APR 26 2011
L-2011-128
10 CFR 50.90

Re: Turkey Point Units 3 and 4
Docket Nos. 50-250 and 50-251
Response to NRC Request for Additional Information (RAI) Regarding Extended
Power Uprate (EPU) License Amendment Request (LAR) No. 205 and Unit 4
Mechanical/Civil Engineering Issues and Correction to Turkey Point Unit 3 Response
Submitted by FPL Letter L-2011-102, Accession No. ML110880060, March 25, 2011

RESPONSE TO NRC RAI REGARDING EPU LAR NO. 205
AND UNIT 4 EMCB MECHANICAL/CIVIL ISSUES

**CORRECTIONS TO RESPONSES FOR RAIS 1 AND 3
SUBMITTED BY FPL LETTER L-2011-102**

Figure 1

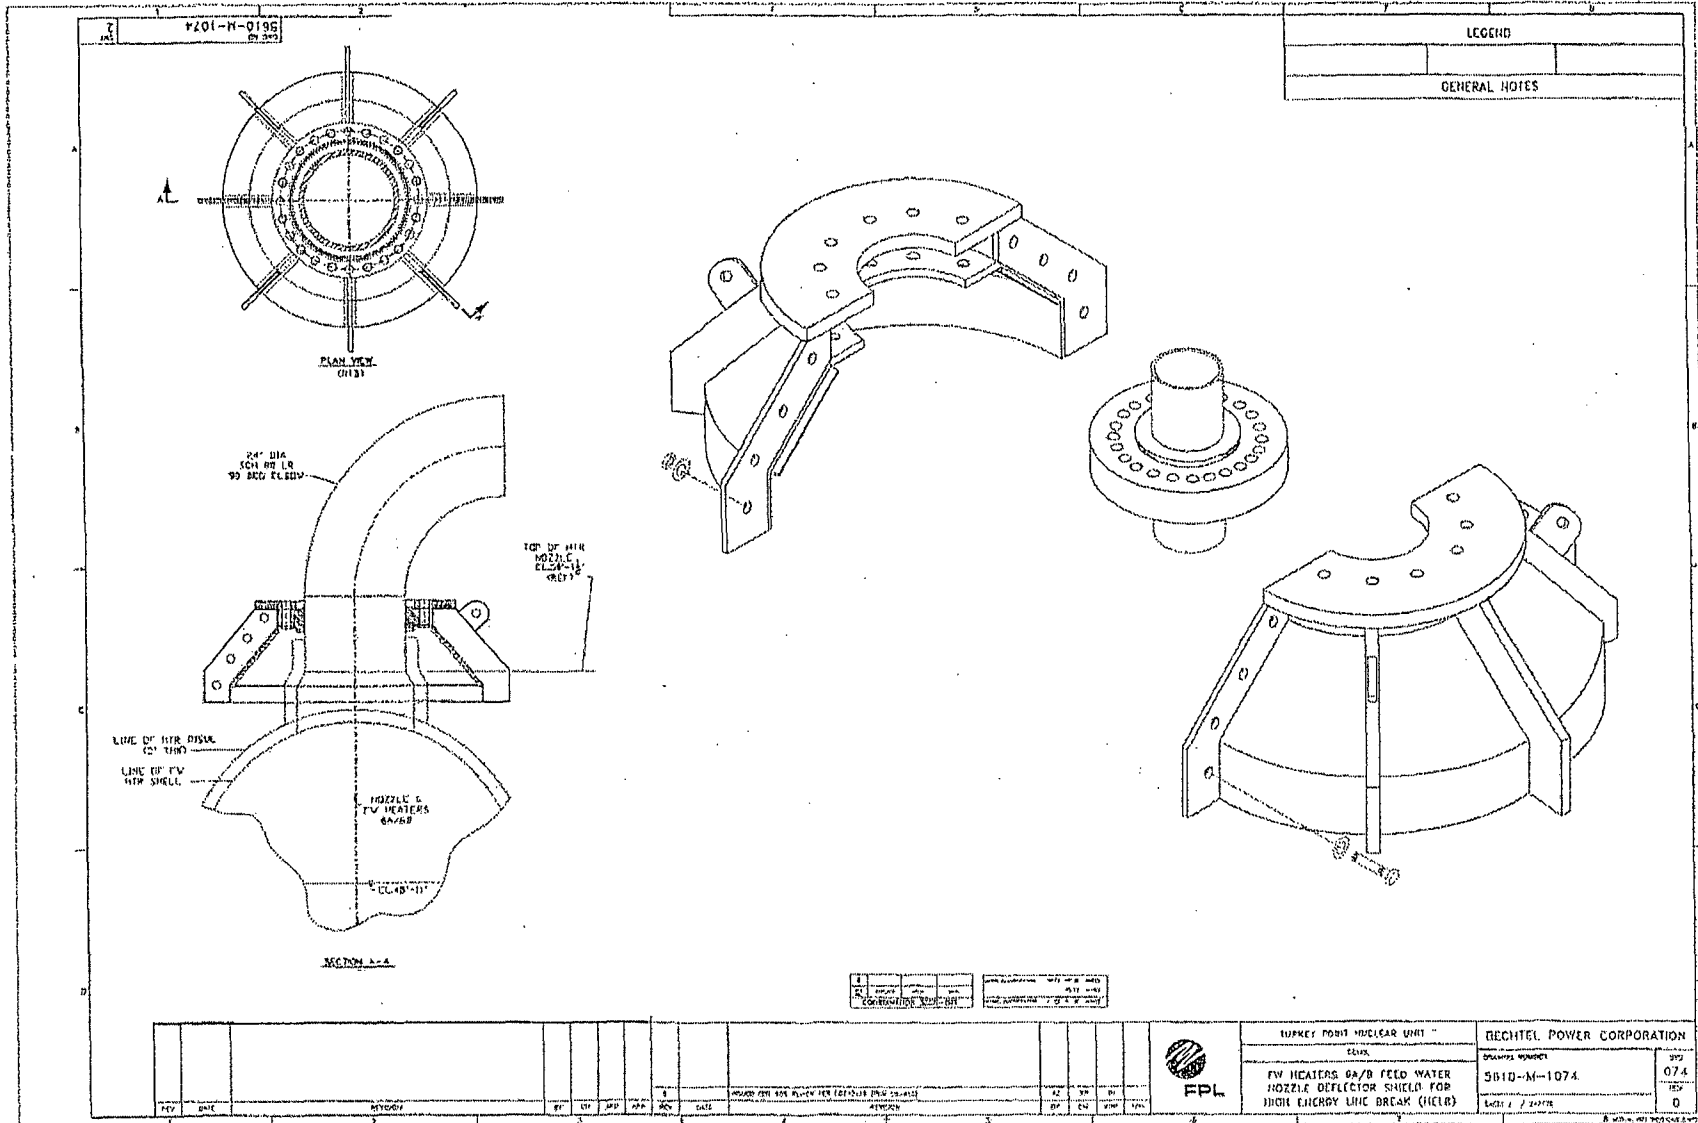
- 3. In Section 2.5.1.3.2.3.4 (Attachment 4, Licensing Report) the licensee notes the replacement of the 6th feedwater heaters will result in resizing of the discharge piping from 18 inches to 24 inches. The jet impingement zones of influence are increasing due to EPU requiring modifications to shield equipment important to safety. These statements indicate that the evaluations (design and analysis) of 24 inch discharge piping, and shield equipment required to support the EPU have not been performed yet. Therefore, the licensee has not provided sufficient technical information for staff's review to determine whether reasonable assurance exists to conclude that the integrity of the required modifications are structurally adequate for the proposed EPU.**

Two of the terminal end break locations for the main feedwater (FW) piping are at the outlet of the PTN Unit 4 E6A/B FW Heaters. Due to increase of the FW Heater outlet nozzle diameter to 24 inches from the current outlet nozzle diameter of 18 inches, there is an associated increase in the size of the pipe break zone of influence. The calculated zone of influence for EPU conditions is 18 ft. for the postulated break (increased from 13.5 ft.). The impact to components important to safety from the increased jet impingement zone of influence has been evaluated in the PTN design change process for the replacement of the number 6 FW Heaters in PTN Unit 4. Walkdowns encompassing an 18 foot zone of influence around the number 6 FW Heater outlet pipes have been performed to identify equipment important to safety. Safety-related pressure transmitters PT-4-464, PT-4-476, PT-4-486, PT-4-496, and PT-4-2604 may be influenced by a circumferential FW pipe rupture at the outlet nozzle terminal ends because of their close proximity to the number 6 FW Heaters HELB zone of influence. These components are located within the main steam valve platform trestle area.

To protect these components, new deflector shields will be installed on the FW outlet piping at the postulated circumferential break locations at each of the number 6 FW Heater outlet nozzles. The shields are designed to redirect jet forces and guide streams in a direction away from the safety-related equipment. The design of the HELB deflector shield is shown in Figure 1.

The design and analytical details for the HELB deflector shield for PTN Unit 4 were completed, and will be incorporated into the FW system modification package. The deflector shields are designed as Class III Structures, Systems, and Equipment, but using the same design allowable stresses as those used for Class I Structures, Systems, and Equipment defined in Appendix 5A of the PTN Updated Final Safety Analysis Report (UFSAR) since the criteria for Class III does not include provisions (allowables) for faulted conditions.

Principal stresses were calculated using standard structural finite element method techniques, under various scenarios of applied loading, from the postulated terminal end break. The maximum principal stresses were determined to be less than the stress limits defined in Appendix 5A of the PTN UFSAR for hypothetical accident conditions. As such, no loss of function is assured.
